Agenda Item # 2 - HOLDOVER SUB-003475-2025

The Cottages at Spring Hill Subdivision

APPLICATION NUMBER 2 DATE December 18, 2025

2nd HOLDOVER COMMENTS

DETAIL SITE PLAN

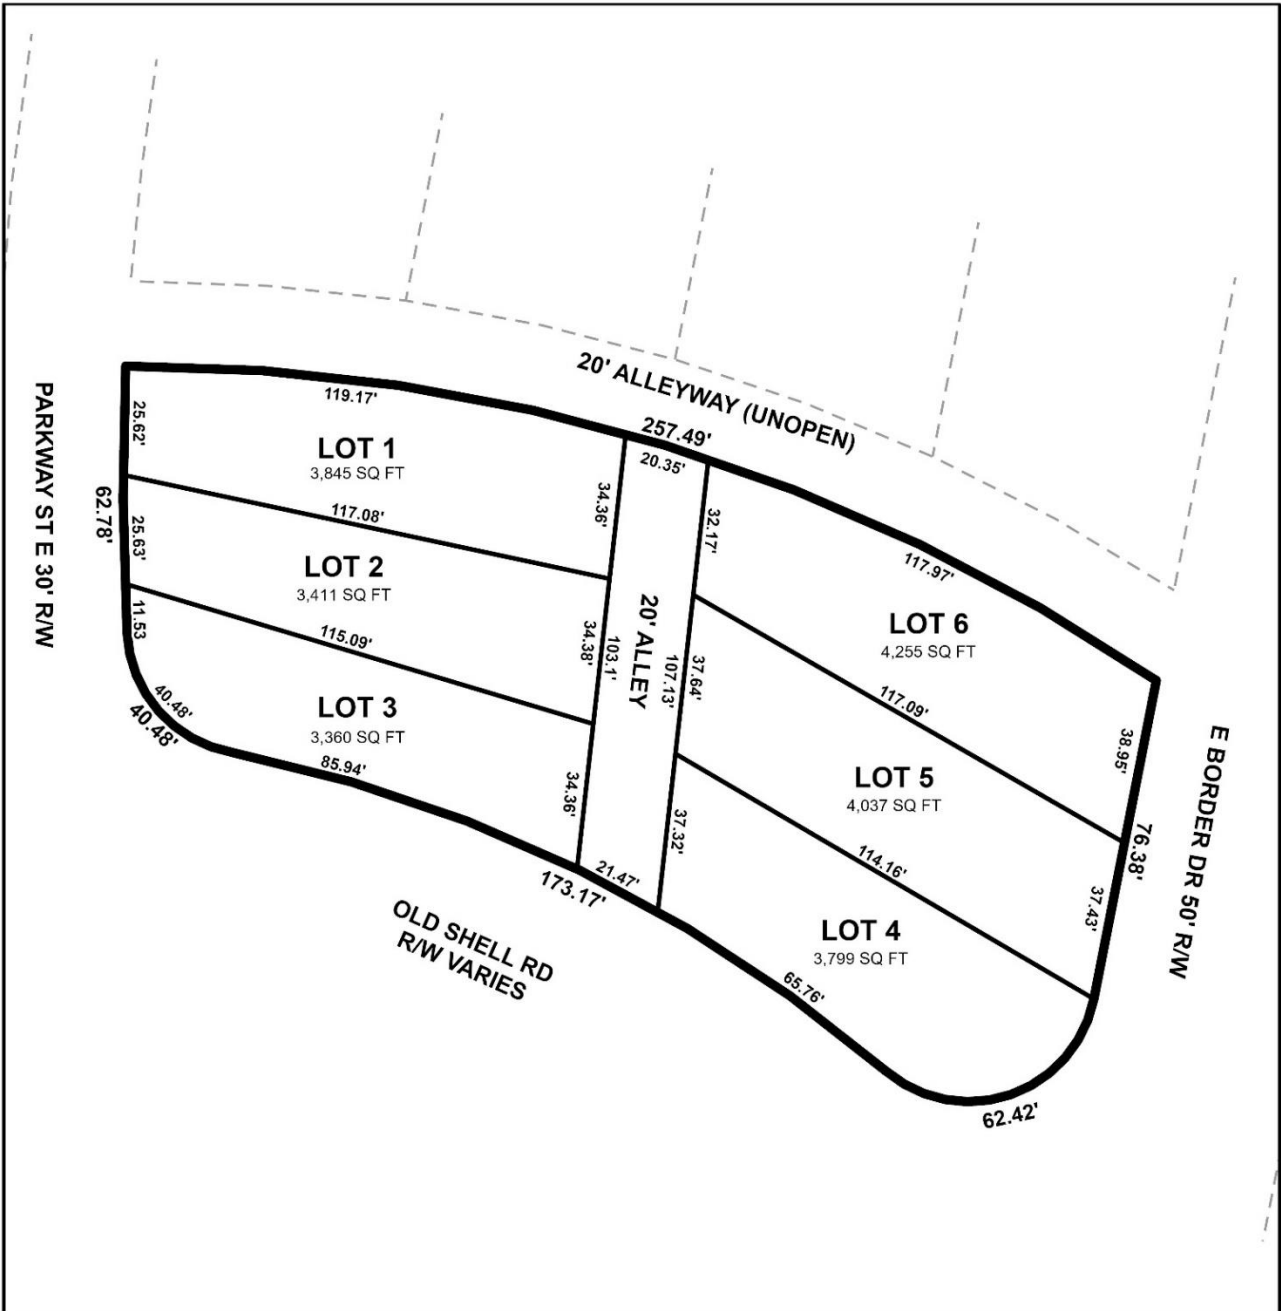
- B. Check the proposed Subdivision Name. The application indicates SPRING HILL COTTAGES, and the drawing indicates COTTAGES AT SPRING HILL.
- C. The PLAT submitted is listed as SHEET NO. 1 of 2. Provide a copy of SHEET 2 of 2 for review.

- D. Correct the address in SURVEY NOTES #2 - from "...570..." to "...5070..."
- E. As shown on the 1984 aerial photo LOTS 1 - 6 will share the 4,000 SF credit provided to the original SF residential lot as follows: LOT 1 - 665 SF, LOT 2 - 665 SF, LOT 3 - 665 SF, LOT 4 - 665 SF, LOT 5 - 665 SF, and LOT 6 - 665 SF. Stormwater detention will be required for any additional impervious area that exceeds the allowable credit for that LOT.

This application was heldover from the Board's November 20th meeting at the applicant's request. The applicant has since submitted a revised preliminary plat which depicts the subject site as a six (6) lot subdivision, rather than seven (7) lots, and depicts a new 20-foot wide alley.

The newly depicted alley is 20-feet wide, and complies with the requirements of Section 9.E.3.(c)(3)5. Of the Subdivision Regulations. As such, if approved, the alley should be retained on the Final Plat, as depicted on the preliminary plat.

1. Revision of the plat to depict that a minimum of 30-feet exists between the subject site and the centerline of Old Shell Road;
2. Dedication to provide 30-feet from the centerline of Parkway Street East;

3. Dedication to provide 30-feet from the centerline of East Border Drive;
4. Retention of the newly proposed 20-foot wide alley;
5. Illustration of the 25-foot maximum building setback line along all street frontages on the Final Plat, excluding the alleys, as measured from any required right-of-way dedication;

The 25-foot maximum building setback line is not depicted along any of the street frontages. If approved, it should be depicted along all street frontages, adjusted for dedication, with the exception of the alley. It should be noted that the SHO allows for no required side yard setback and a five-foot (5') minimum rear yard setback. To reduce confusion, it is recommended that the setbacks be removed from the "Site Data Table".

The preliminary site plan submitted depicts a five-foot (5') private drainage and building maintenance easement along the proposed shared lot lines, as well as an eight-foot (8') private drainage easement along Old Shell Road, Parkway Street East, and East Border Drive. Therefore, a note should be required on the Final Plat, if approved, stating that no structure shall be constructed or placed within any easement without the permission of the easement holder.
